VESTEL Service Bulletin

Model: All models with AK37 Chassis.	<u>Service</u> <u>Bulletin No:</u> 122	Priority ()S. All product. ()A. Items in Customer / Dealer stock / Service return goods. ()B. Customer stock / Units returned for Service. (X)C. Sold items returned for Service. ()D. Only Units returned to this bulletin. ()E. Others
SUBJECT : IC 800 defect		DATE : August 07, 2002

Model: 33'' and 28'' 16:9 32'' 16:9 models with AK37 Chassis.	<u>Service</u> <u>Bulletin No:</u> 155	Priority ()S. All products. ()A. Items in Customer / Dealer stock / Service return goods. ()B. Customer stock / Units returned for Service. (X)C. Sold items returned for Service. ()D. Only Units returned to this bulletin. ()E. Others
SUBJECT : IMPROVEMENT ON THE RELIABILITY OF 33'' and 16:9 models DATE : APR 17, 2003

Service
Bulletin No: 135

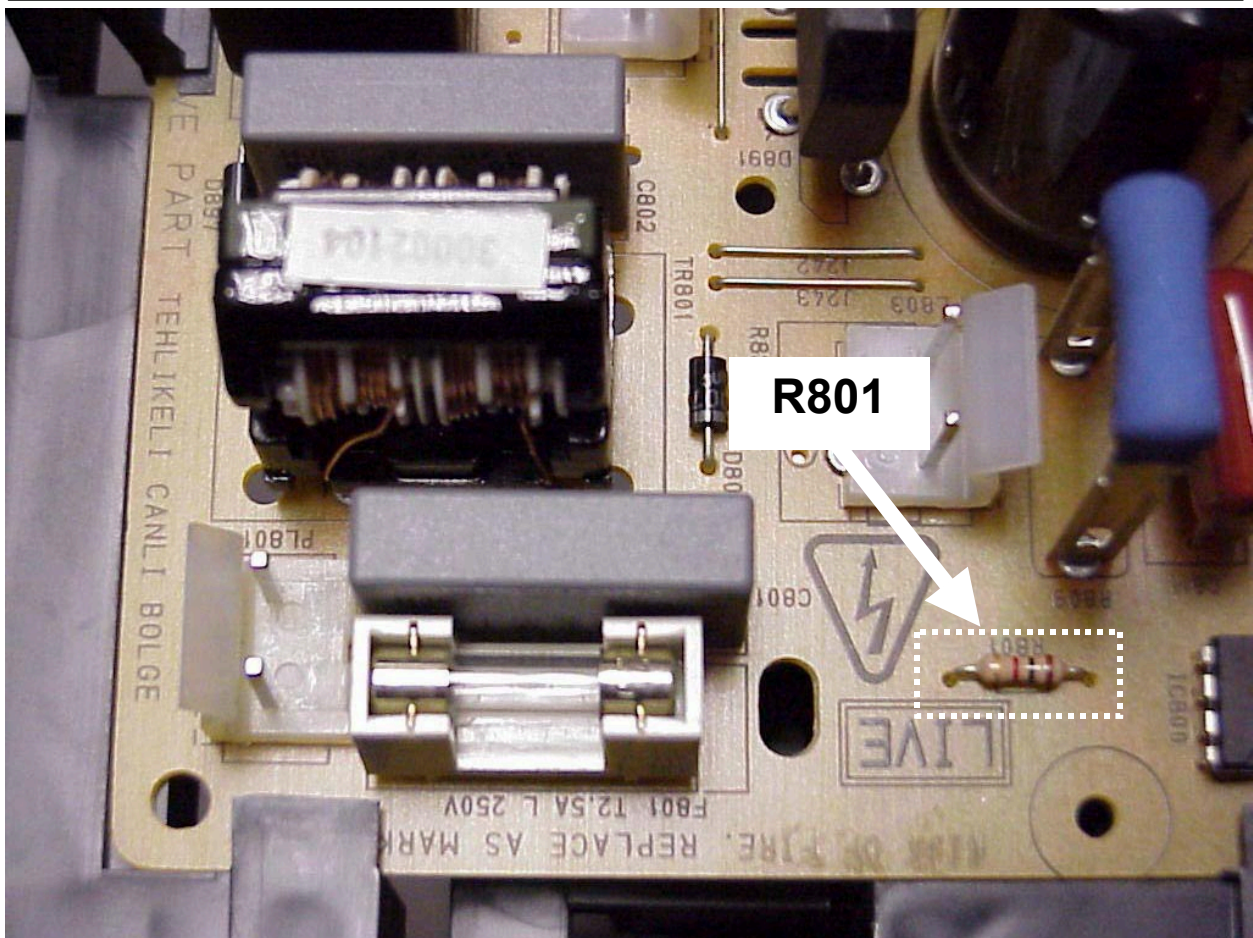
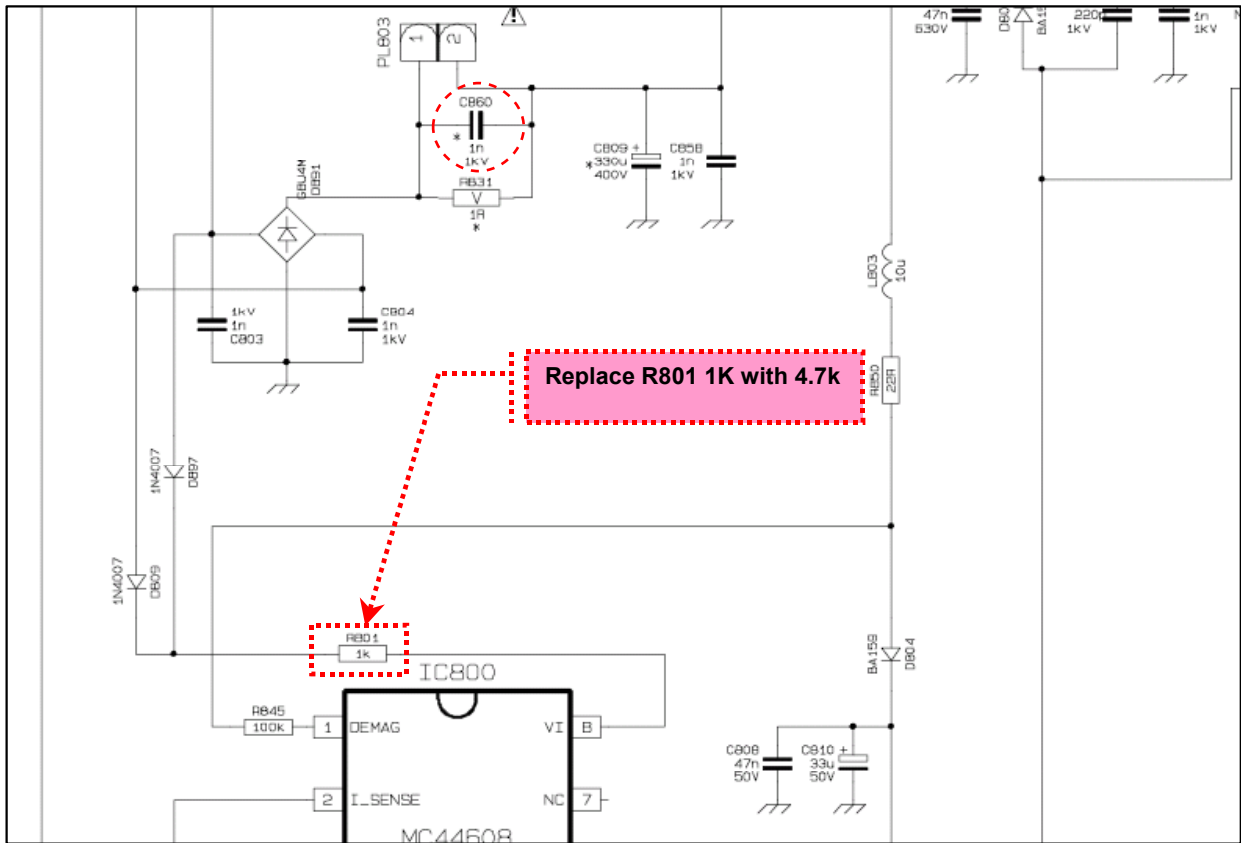
Symptom: Set dead.

Cause: Damage to IC800 has occurred due to spurious mains spikes.

Cure: Change the defective IC800 MC44608P (part number 30011968) and in order to improve IC800 resistance to spikes change R801 from RES CF 1/4W 1K J to RES CF 1/4W 4.7K J .

As a preventative measure this resistor should be changed even if IC800 has not failed
